M42 Junction 6 Development Consent Order (TR010027) - Non-material change request

Change 1: Proposed change to the southern extent of the Limit of Deviation for Work No. 63 (Severn Trent Aqueduct)

Change 2: Attenuation Tank Relocation (Work No. 34)

Change 3: Parcels of land to be removed from the Order Limits

Appendix F – Land Plan Sheet 2

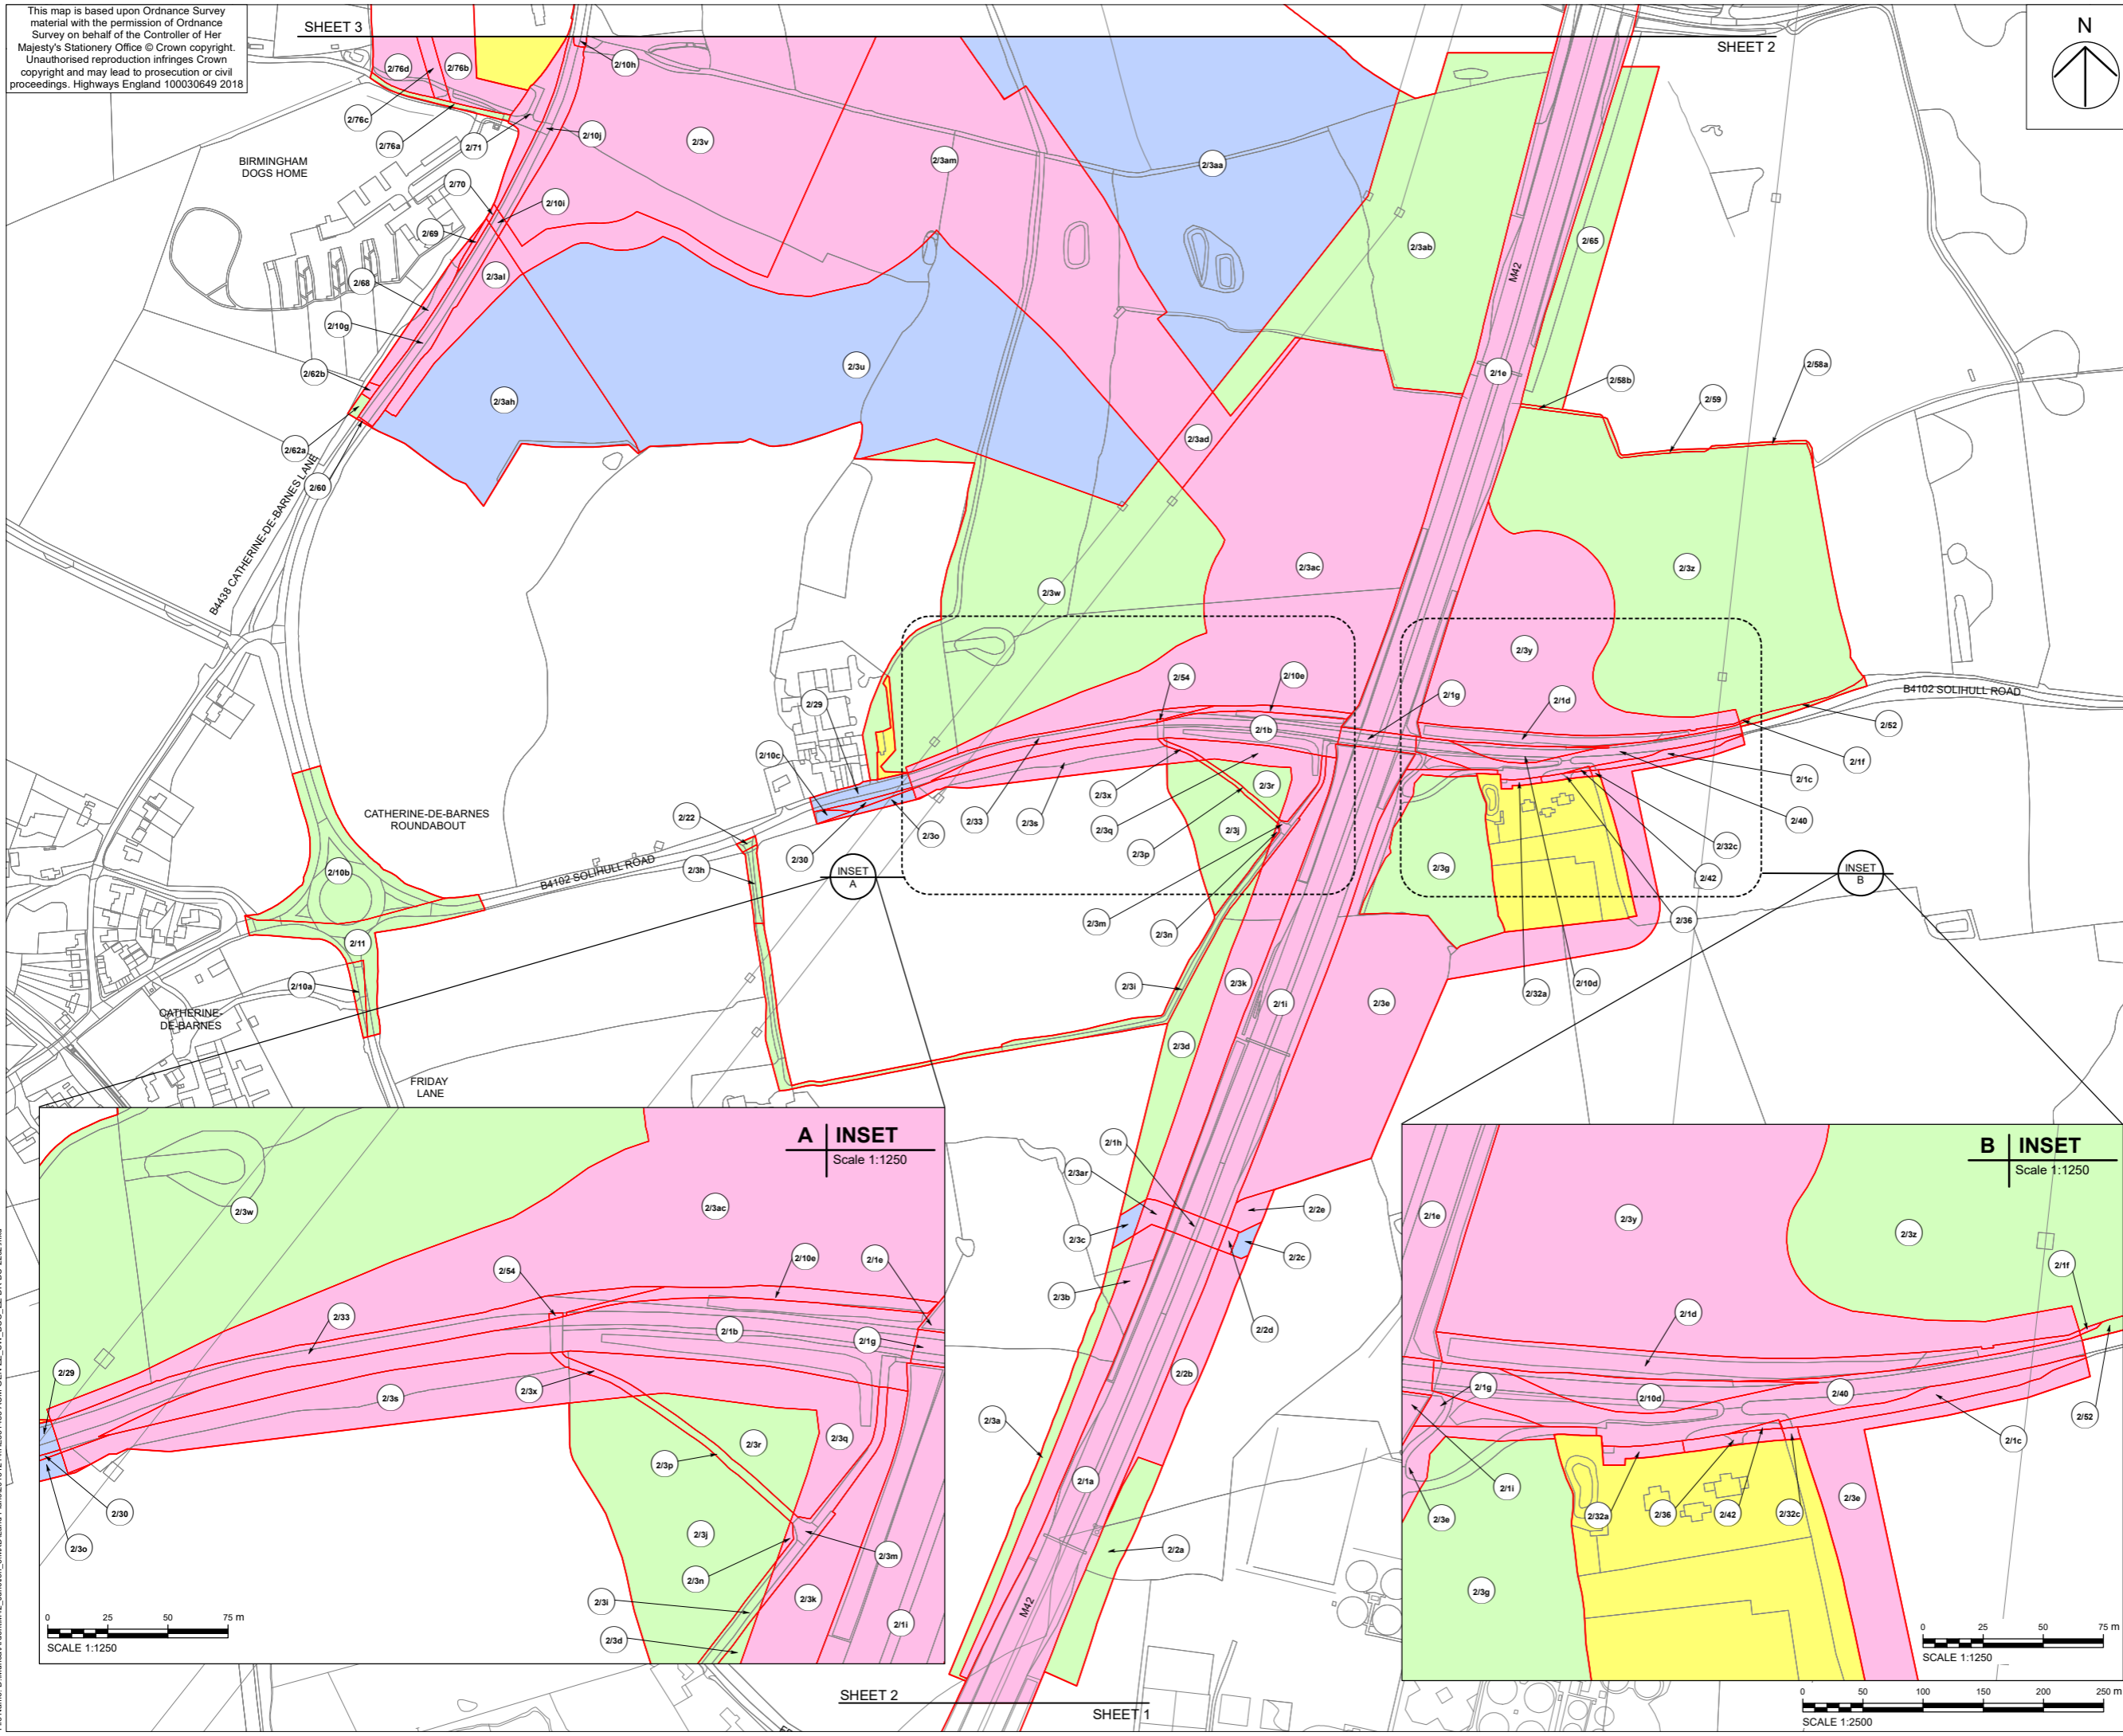
As a result, the Applicant has proposed to move the attenuation tank to an area of land (parcel 2/10j and part of 2/71) (see **Appendix F**) which are already proposed to be acquired permanently to create new highway land, although they are outside the current LoD for Work No. 34.
